Stormwater management concept plan – 177 New Bright Road Ocean Shores

However, to comply with Council request for additional information under Clause 36 of the *Environmental Planning and Assessment Regulation 2021* the stormwater concept plan has been provided below and is attached:

Stormwater concept plan details

Figure 2: Proposed and existing building floor levels. (Source: Byron Shire Council GIS).

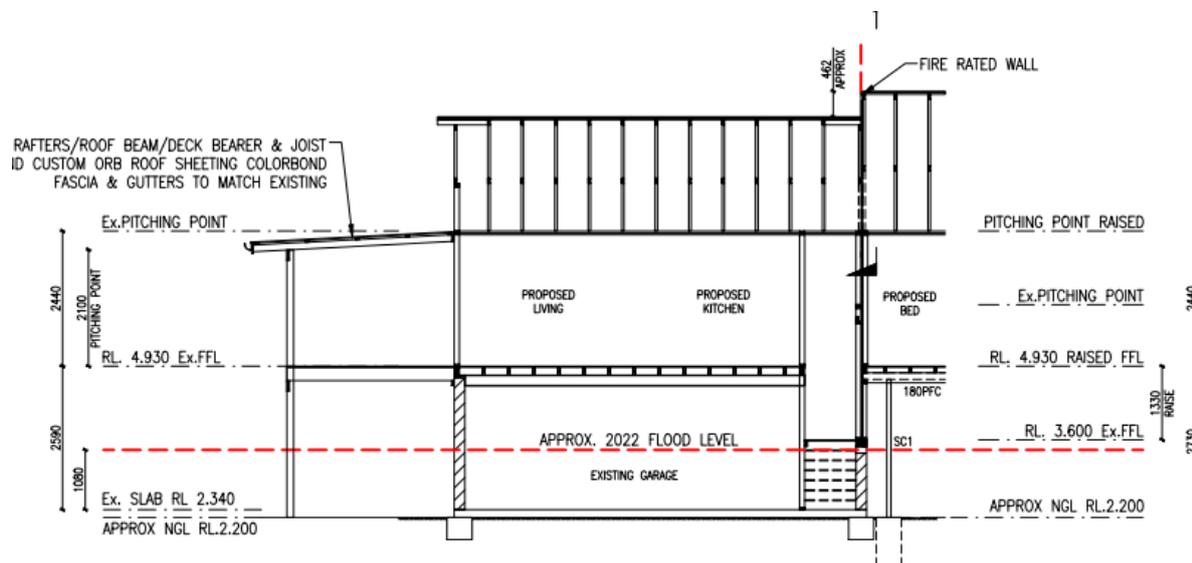
2. Proposed and existing building locations and floor levels.

Response: The development plans show the proposed / existing building locations and floor levels.

Figure 4: Location of existing stormwater system. (Source: Byron Shire Council approval).

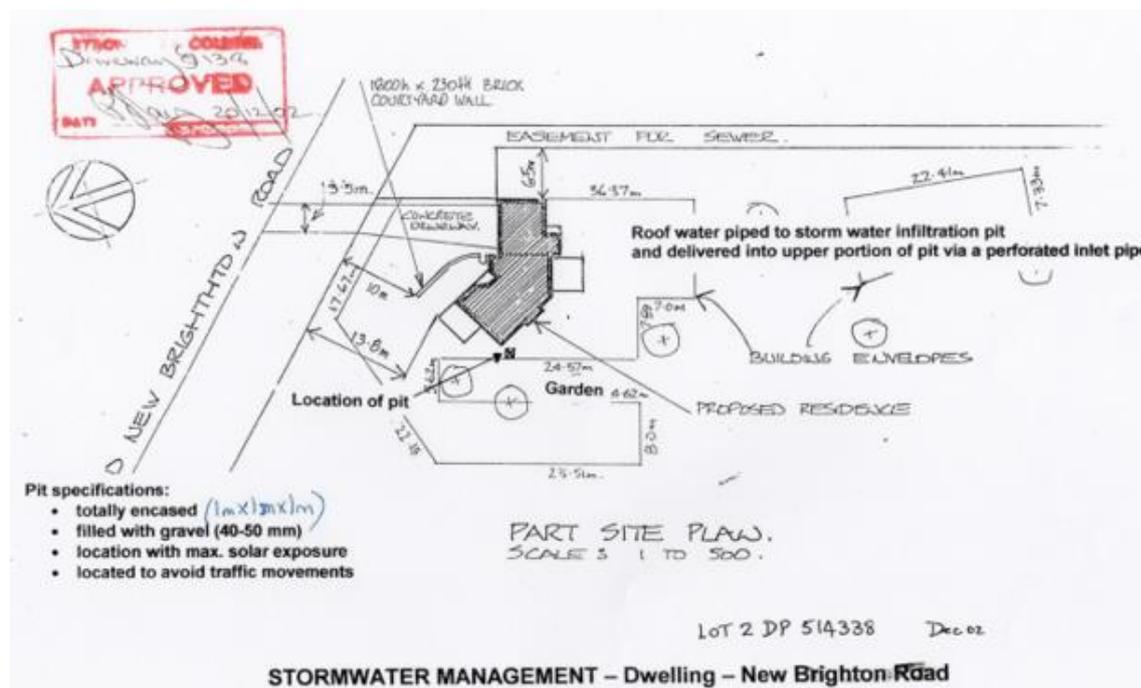
14. Justification that the proposed design measures will not cause adverse stormwater impacts on adjoining properties

Response: The proposed design measures will be in addition to the existing drainage that has been existing on this site for approximately 20 years (see previous design measures below). There have been no issues raised from adjoining neighbours, with stormwater that is not absorbed within the large allotment eventually percolating into the natural drainage channels on the property. As such the proposed improvement will not only not cause adverse stormwater impacts on adjoining properties, with the additional harvesting of the existing roof areas for SWS and BASIX water supplies and the additional disposal tunnel trench likely reduce the existing potential runoff.
